Re: Rancho Seco Nuclear Generating Station  
ISI/IST Program. Reid letter to Mattimoe,  
dated 10/17/79.

Per the request in your letter of October 17, 1979, please find enclosed formal documentation of our discussions with staff on October 3 and 4, 1979, regarding modifications to our ISI/IST Program. Question numbers correspond to those submitted to us on September 21, 1979, by Mr. Dan Garner and included as Enclosure 2. The actual meeting notes have been included as Enclosure 3.

## VALVE TESTING PROGRAM

ENCLOSURE 1: RCS001, RCS002, CFS001 and CFS002  
DISC MOVEMENT VERIFICATION

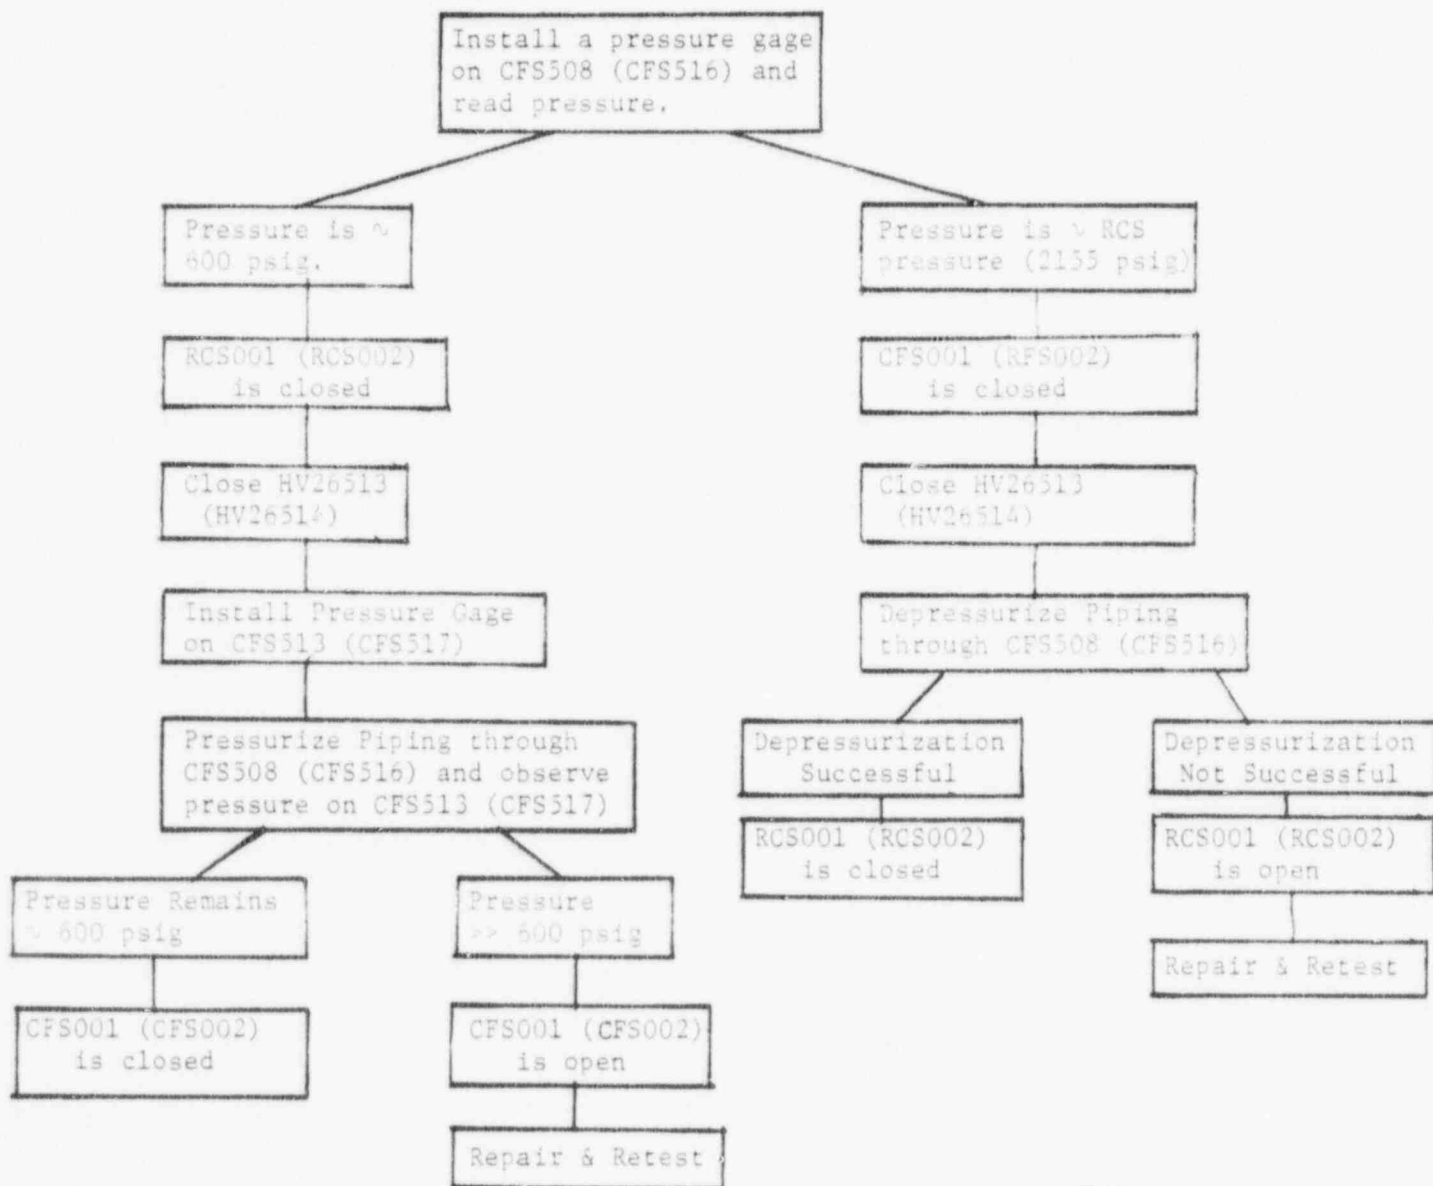
2. Question: How are valves RCS001 (M522/D7), RCS002 (M522/D9), CFS001 (M522/D7) and CFS002 (M522/D9) full stroke exercised?

Discussion: These valves are incorrectly listed in the Valve Testing Program Tabulation as Category A/C. They should be Category C only. In addition, these valves are listed as being full stroke exercised during each Cold Shutdown. The valves are partial stroked only at Cold Shutdown and Refueling.

Consideration of verification of disc movement will be made during Refueling Outages by the method shown in Enclosure 1.
